**Re: Christina Lake Thermal Project Phase H and Eastern Expansion
Project Update and Supplemental Information Request 2 Responses
AER Application No. 1758947
EPEA Application No. 019-48522**

The purpose of this document is to provide responses to the Round 2 SIR package and provide updated information regarding the Project (Project Update). This document is organized into two parts as follows:

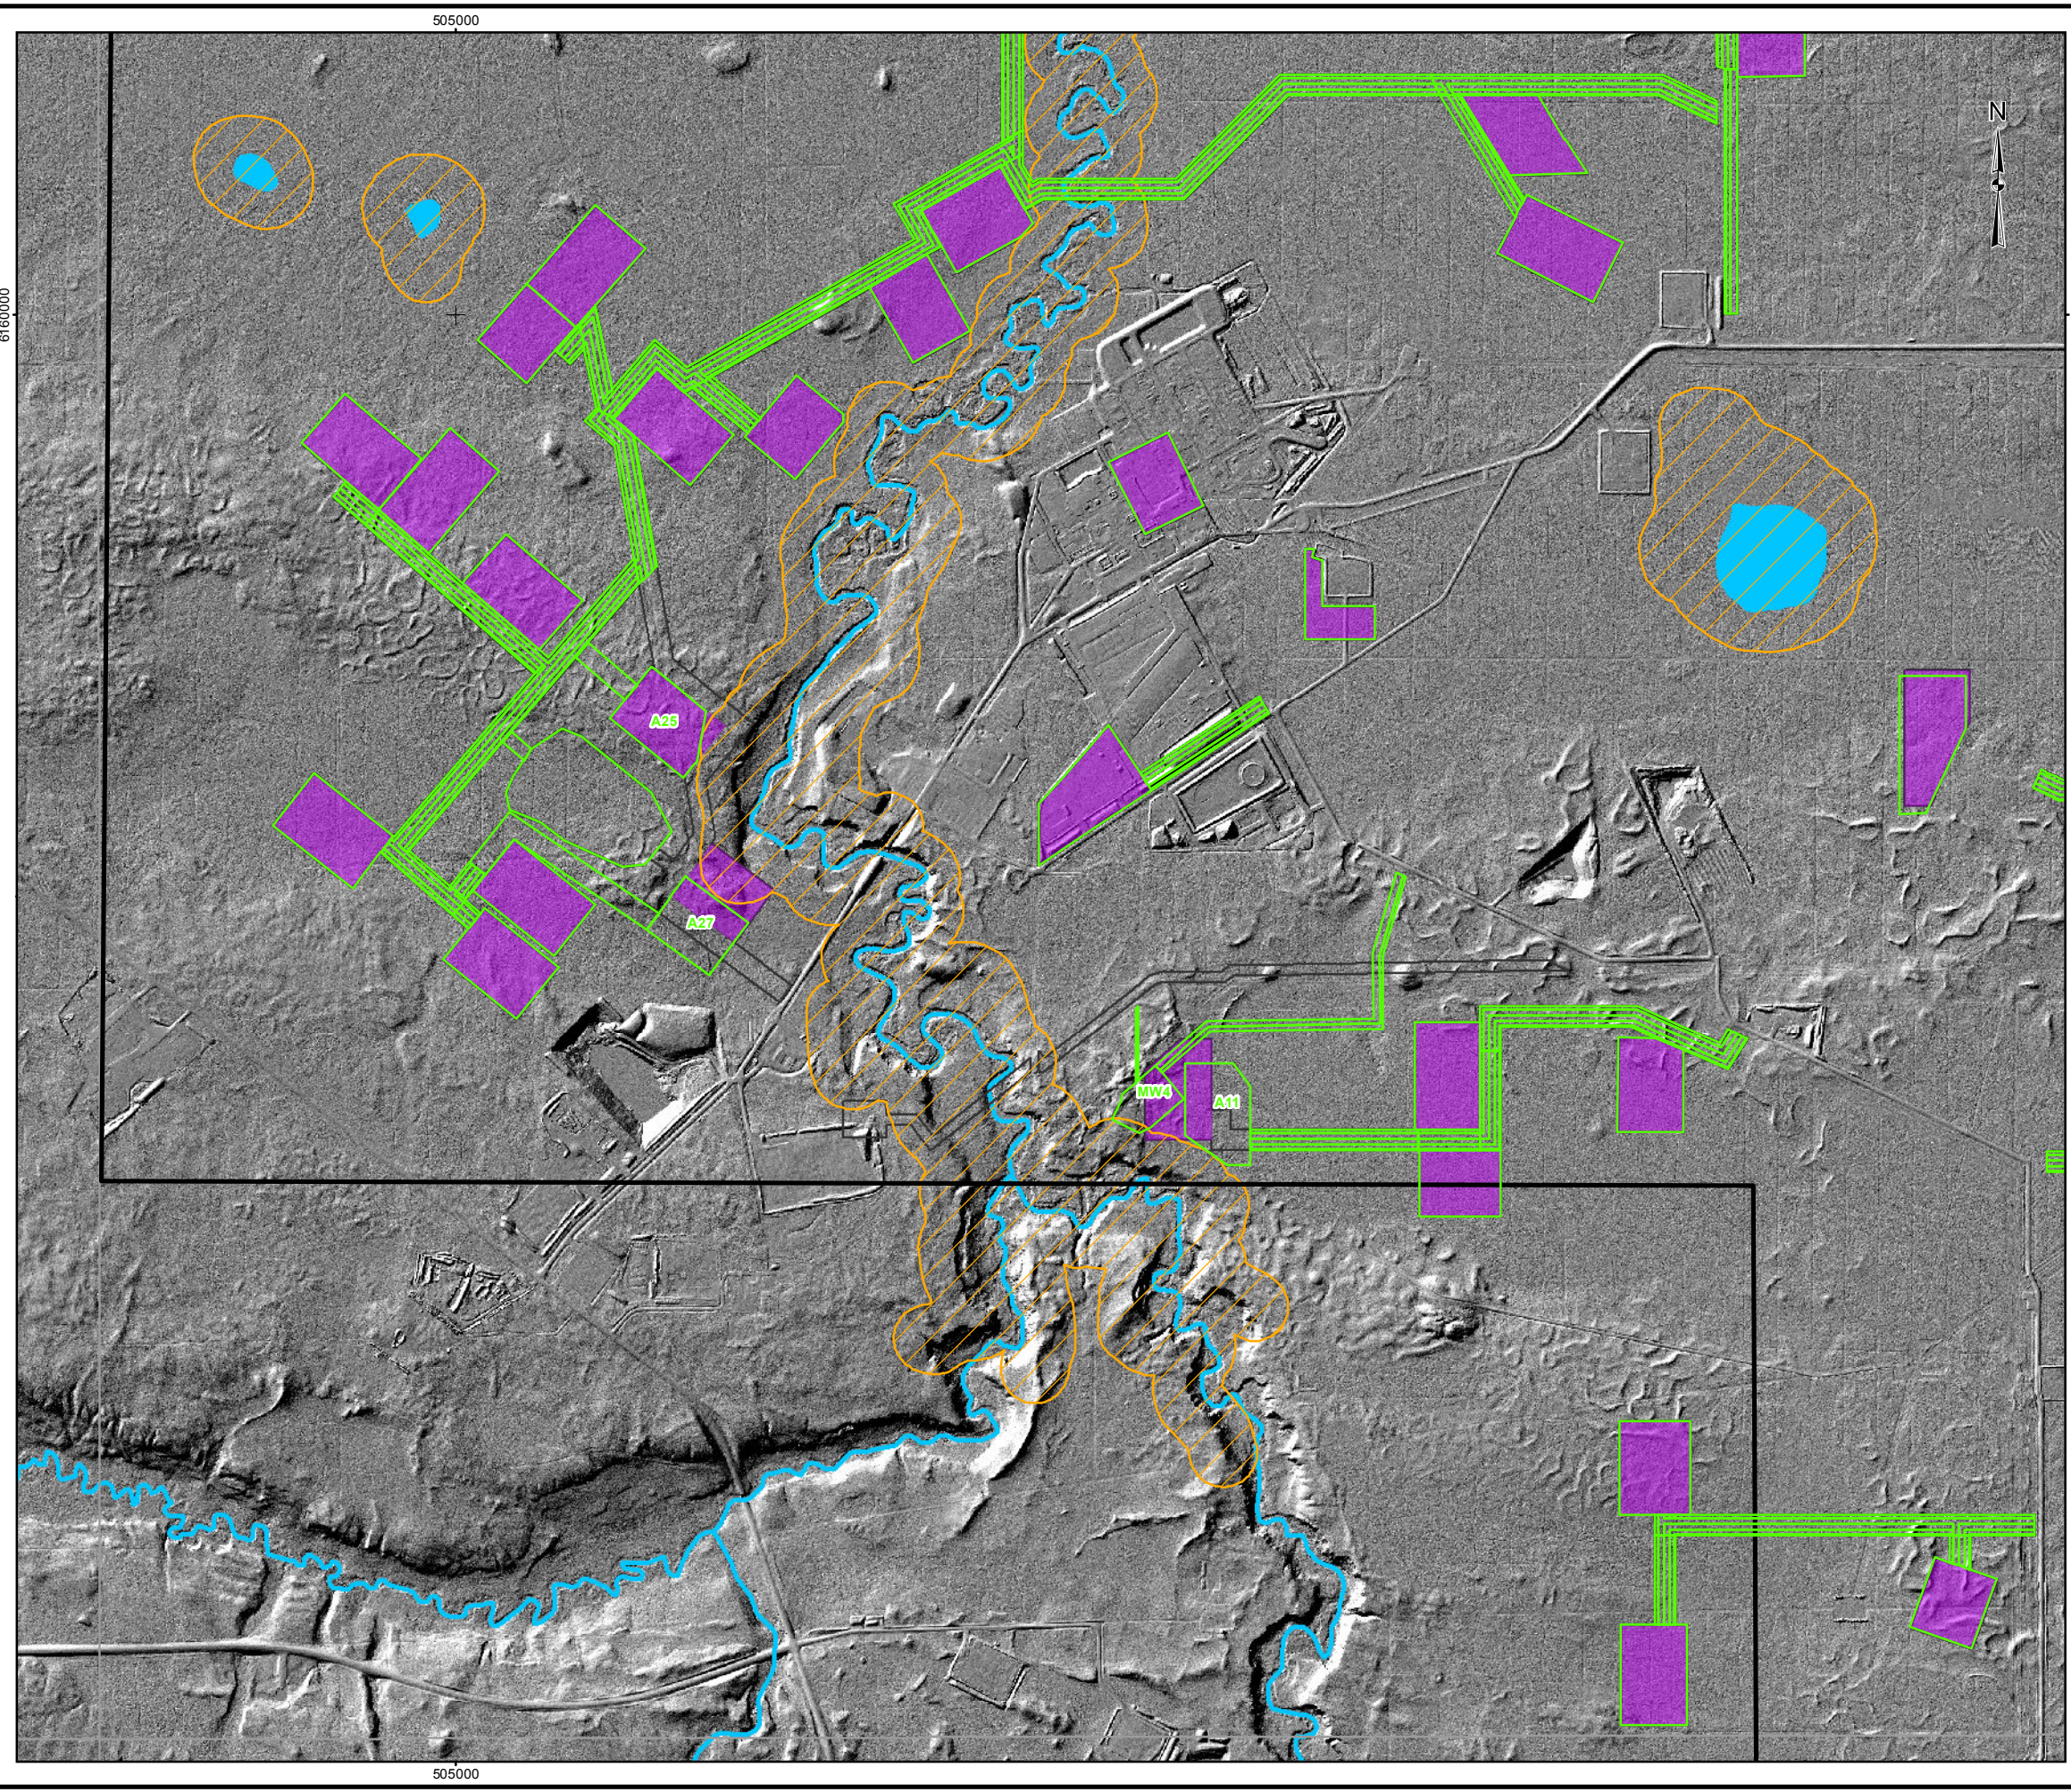
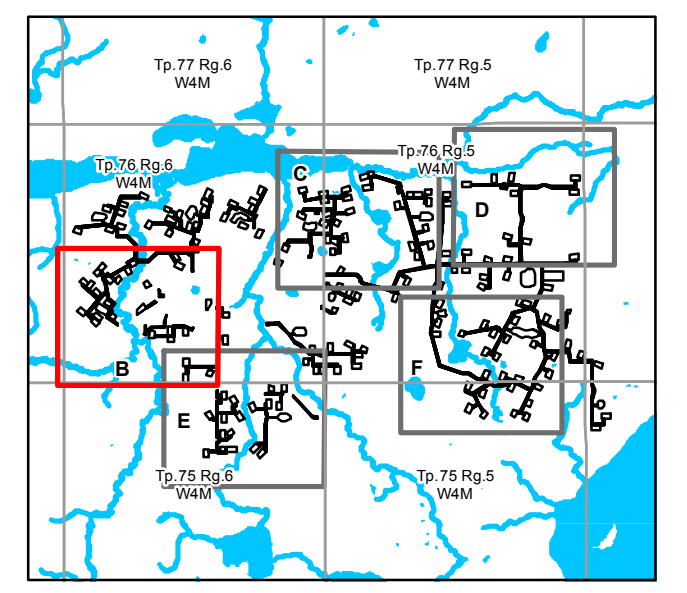
- b. **Contrast the identified locations with potential alternate locations outside of the 100m setback. Include a discussion of the surface and subsurface constraints that were considered.**

- a. Cenovus has reviewed the footprint relative to the waterbody and watercourse setback requirements and has prepared an alternate proposed footprint as shown in [Figure 24-1A](#) (overview) and [Figures 24-1B to 24-1F](#) (detailed views). Well pads previously located within the 100 m buffer have been relocated outside of the buffer. The updated distances from the watercourse or waterbody are provided in ESRD Round 2 SIR 26, [Table 26-1](#).

- b. The proposed alternative well pad locations are provided in [Figures 24-1A to 24-1F](#). Subsurface and surface constraints considered are discussed in the response to ESRD Round 2 [SIRs 7 and 11](#).

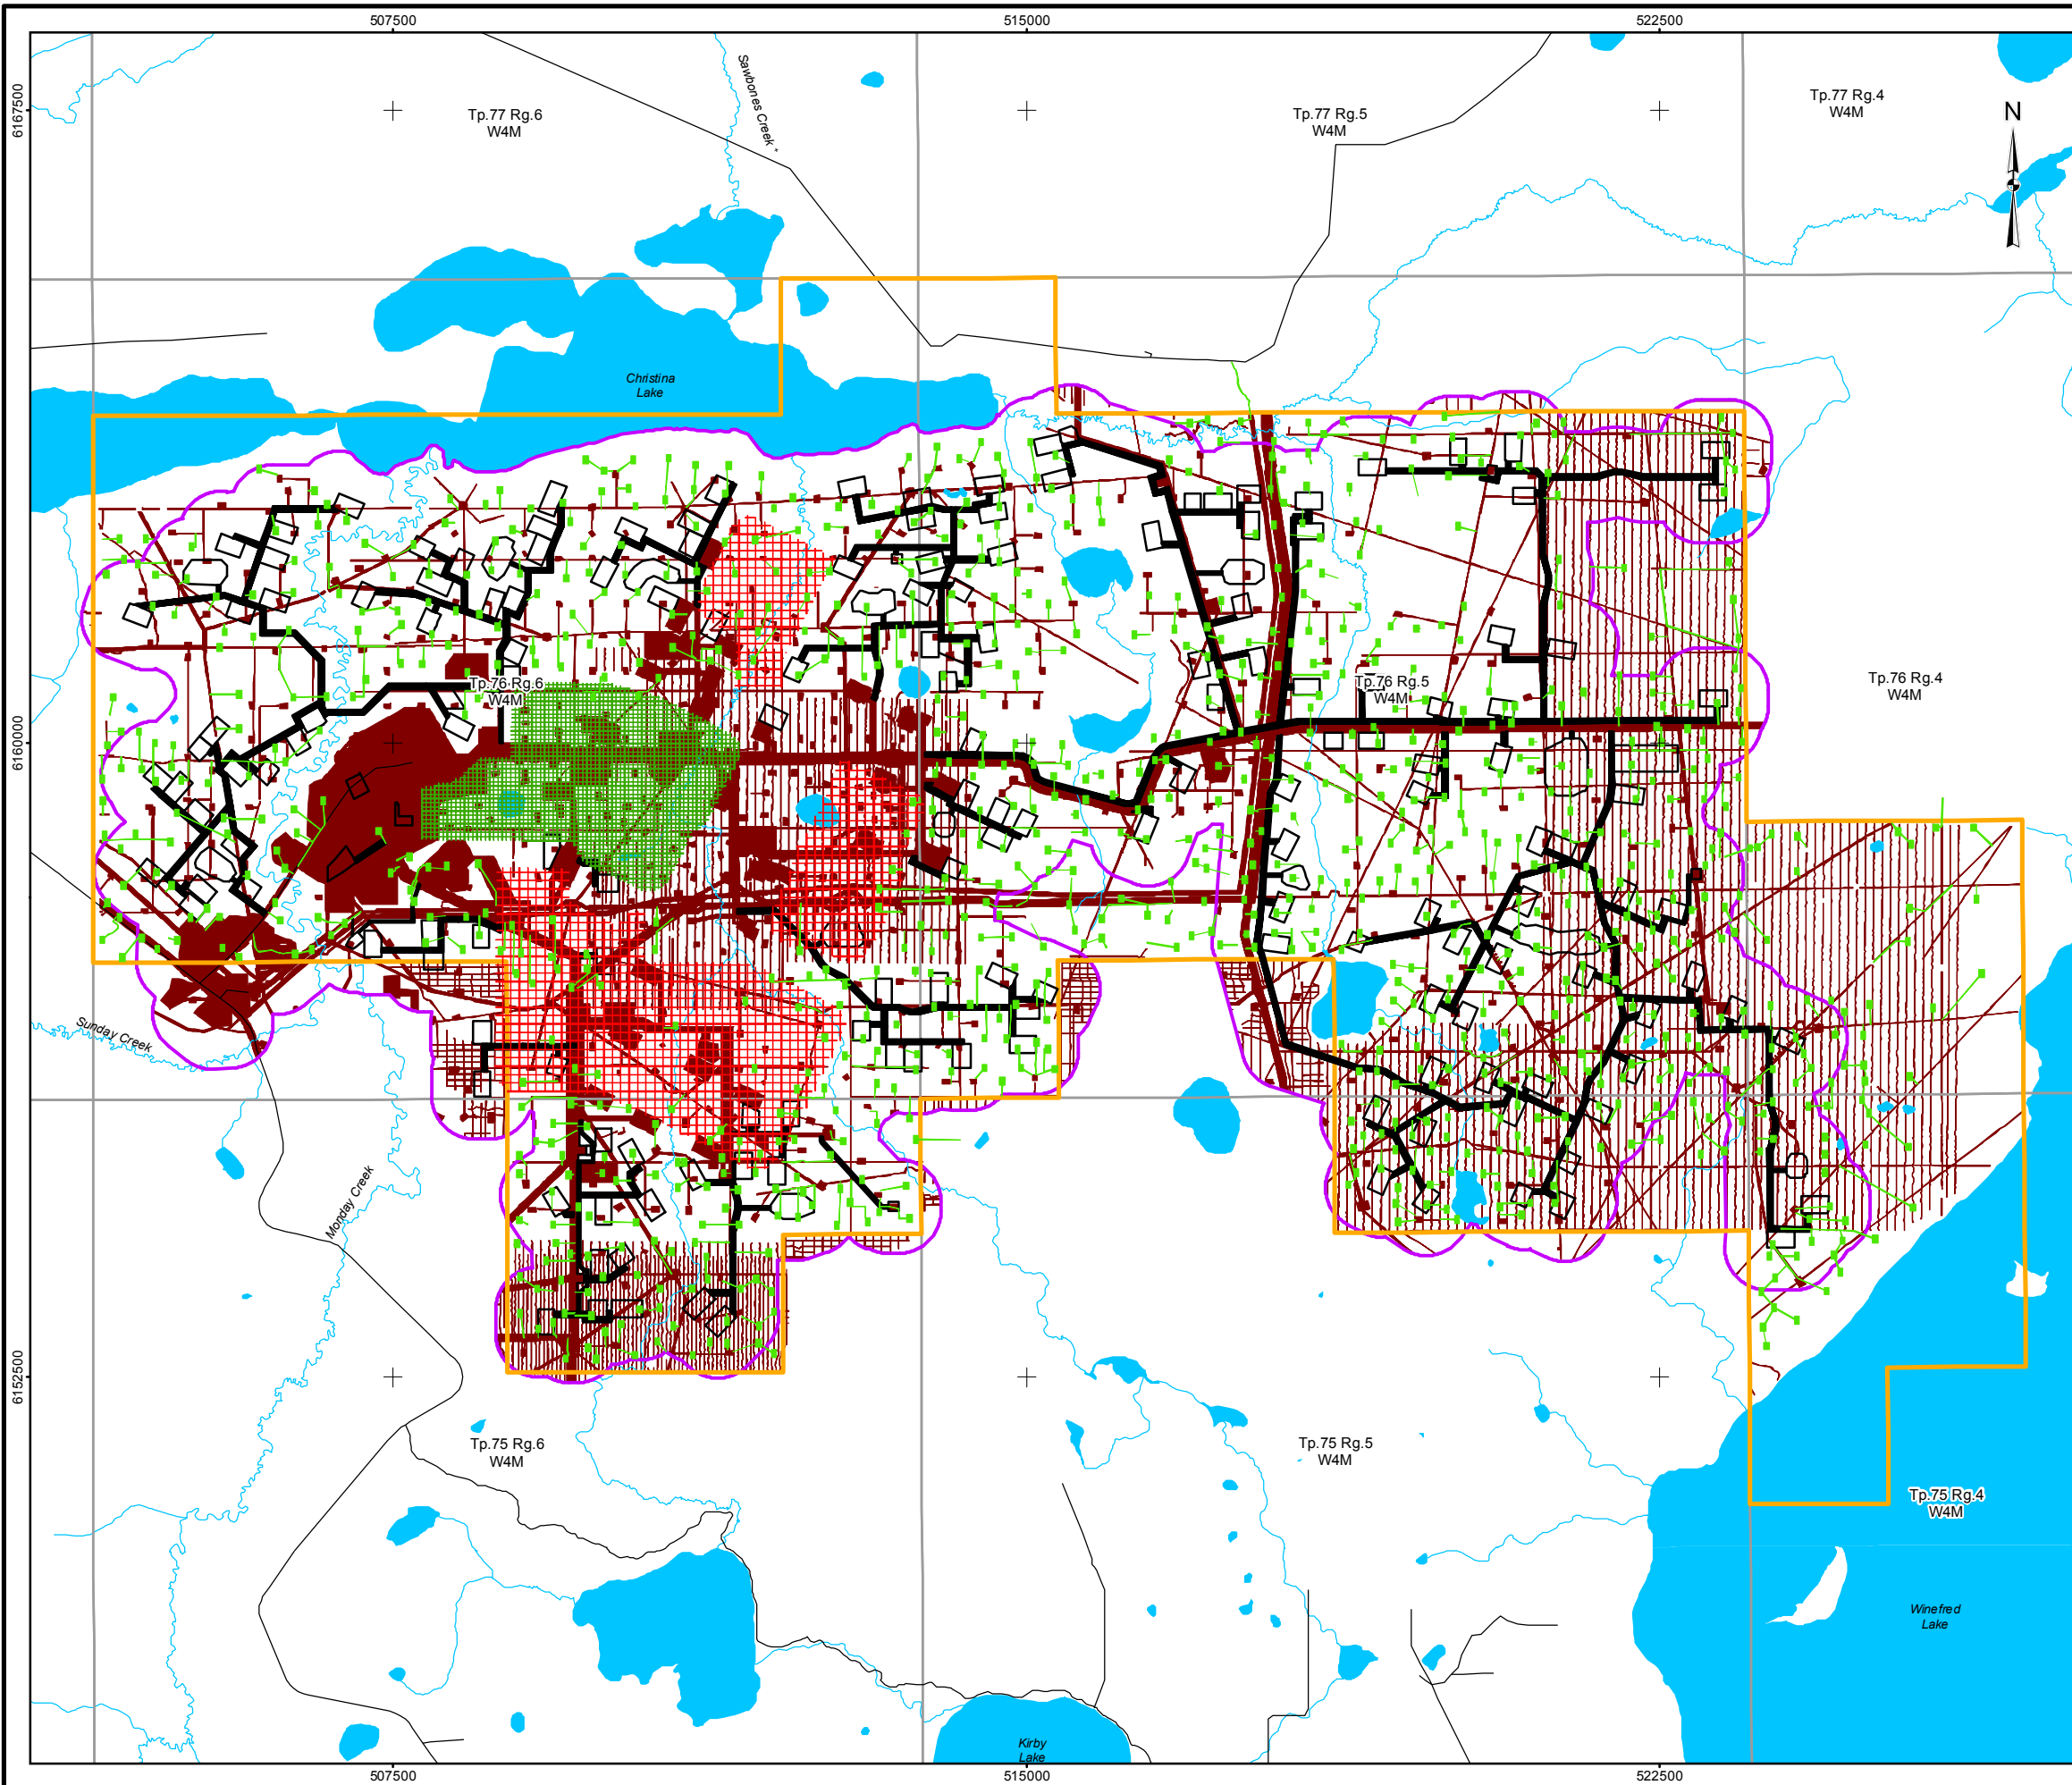
- 36. ESRD Supplemental Information Request Round 1, SIR 138e, Page 278. Cenovus was asked to provide detailed information regarding proposed 3D exploration programs. Instead, Cenovus described only existing and approved linear disturbances. As per TOR 3.7.2[A]f), proponents must describe and assess the potential impacts of the Project to wildlife and wildlife habitat considering the potential effects on wildlife from the Proponent's proposed and planned exploration, seismic and core hole activities, including monitoring/4D seismic.**

- a. See [Figure 36-1](#) for an illustration of the proposed and planned exploration activities required for Cenovus to develop the Phase H and the Eastern Expansion Project.
- b. The estimated habitat loss by ecosite due to proposed and planned exploration activities is presented in [Table 36-1](#) and losses to old growth forest are presented in [Table 36-2](#). The “% of Type” shown in the last column of [Tables 36-1](#) and [36-2](#) indicate percent habitat loss in the LSA. A buffer for exploration activities located outside of the LSA was not applied; therefore, the percentages presented are considered conservative as they are greater than they would have been if a buffered LSA was used. Exploration activities add 23 ha of disturbance to old growth, and increase overall disturbance to old growth by 5% ([Table 36-2](#)).
